2			ADDENDUM 01			10-09-2026		
1			ISSUE SET			08-18-2026		
Revision#			Description			Date:

CONSULTANTS		ARCHITECT OF RECORD		STAMP		Office of Construction and Facilities Management		Drawing Title 3D IMAGES		Phase		Project Title RENOVATE FIRST FLOOR FOR NEW KITCHEN FOR THE SIOUX FALLS VA MEDICAL CENTER		Project Number VA #438-21-403 SGA #201956	
			CIVIL: Ulteig Ulteig Engineers, Inc. 5701 South Corporate Place Sioux Falls, SD 57108 Phone: 605-323-2306		STRUCTURAL: ERA ERICKSEN ROED Ericksen Roed Associates 2550 University Ave W Suite 423 S St. Paul, MN 55402 Phone: 651-251-7570		MEP: DUNHAM Dunham Associates, Inc. 50 South Sixth St Suite 1100 Minneapolis, MN 55402 Phone: 612-465-7550		FOOD SERVICE: RIPPE ASSOCIATES Foodservice Design + Consulting Rippe Associates 10400 Yellow Circle Dr Suite 100 Minneapolis, MN 55343 Phone: 952-933-0313		STONE GROUP ARCHITECTS Stone Group Architects, Inc. 600 East 7th Street Sioux Falls, SD 57103 Phone: 605-271-1144				U.S. Department of Veterans Affairs		Approved:

Drawing Number
MP101

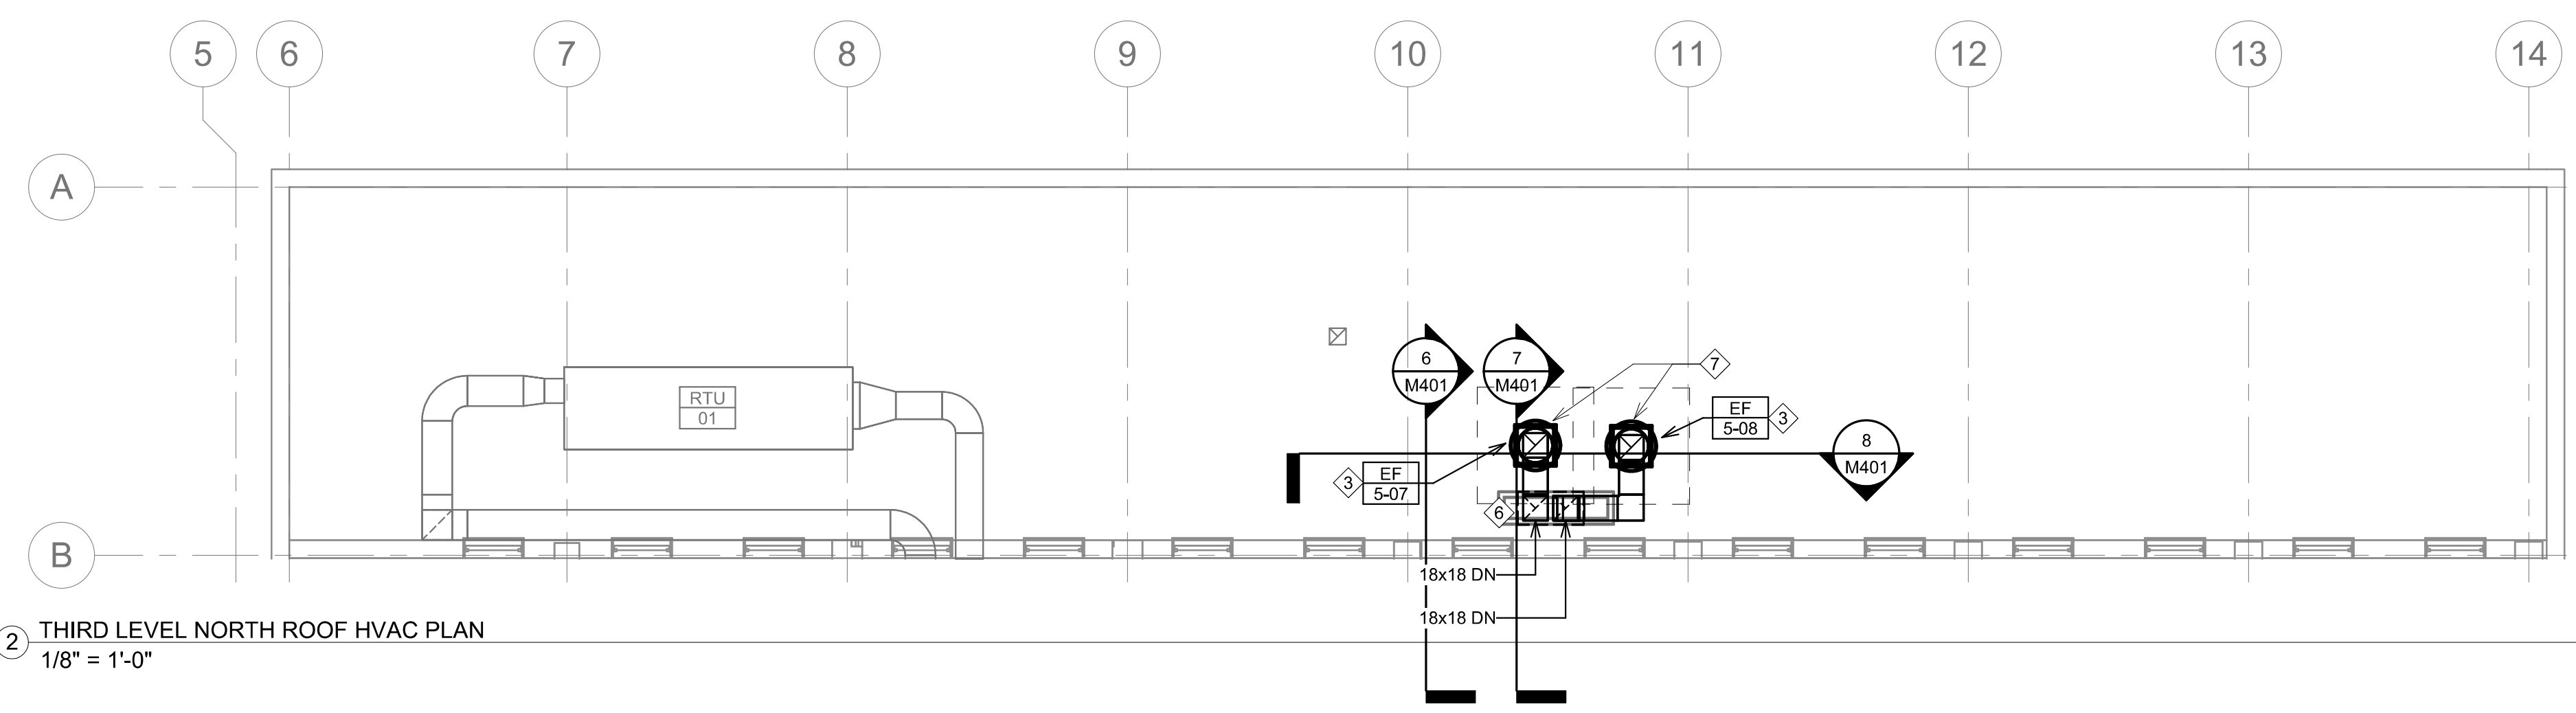
- KEY NOTES:**
- 1 MECHANICAL CONTRACTOR TO INSTALL WALK-IN COOLER/FREEZER CONDENSING UNITS PROVIDED BY KITCHEN CONSULTANT.
- 2 CONDENSING UNITS NO LONGER INSTALLED WITHIN MECHANICAL ROOM. SEE ADDENDUM #1 FOR REVISED OUTDOOR LOCATIONS.

- 3 THIS NOTE WAS DELETED VIA ADDENDUM #1. REFER TO REVISED REFRIGERANT PIPE ROUTING ON THIS DRAWING.
- 4 THIS NOTE WAS DELETED VIA ADDENDUM #1. REFER TO REVISED REFRIGERANT PIPE ROUTING ON THIS DRAWING.

Project Number
VA #438-21-403 SGA #201956
Building Number
5
Drawing Number
MH201

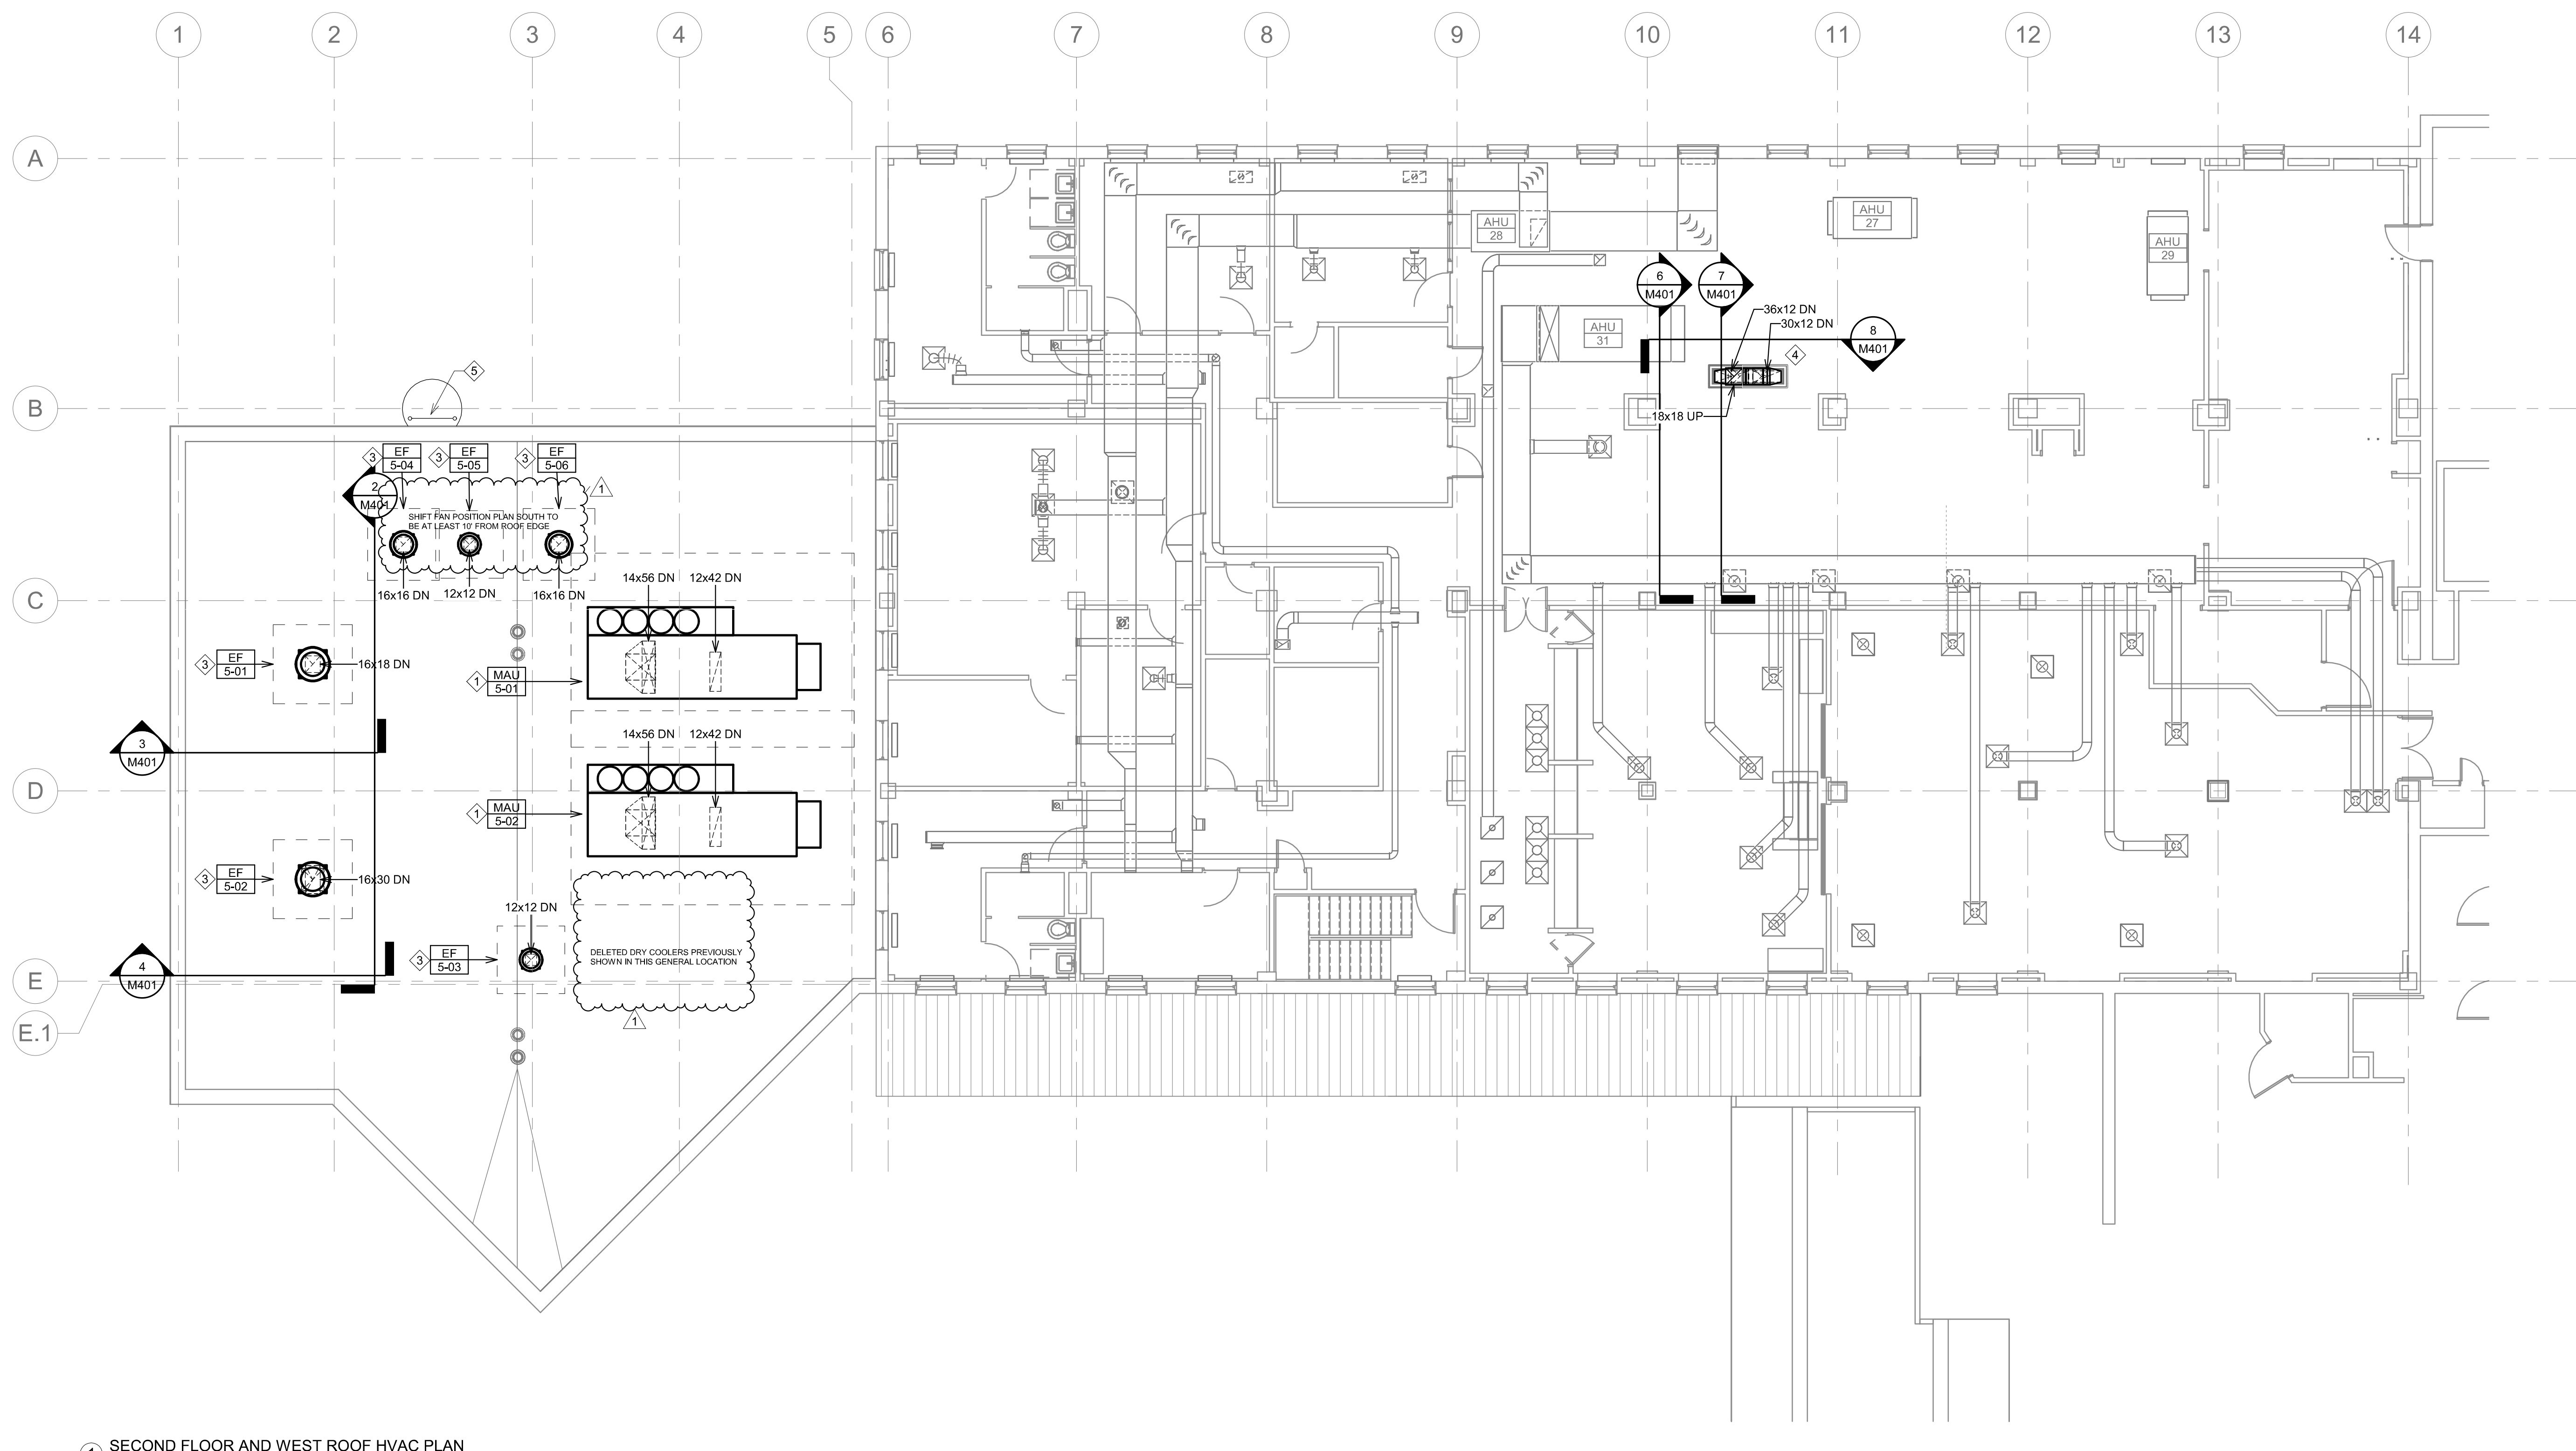
- 1 MAKE-UP AIR UNIT.
- 2 DRY COOLERS ELIMINATED VIA ADD#1.
- 3 SUPPORT PIPING ON ROOF AT MAXIMUM 5'-0" SPACING AND AT CHANGE IN DIRECTION.
- 4 EXISTING STEAM RADIATORS AT WINDOWS TO REMAIN. OPERATION OF STEAM RADIATORS TO PROVIDE TEMPORARY HEAT TO SHELL SPACE.
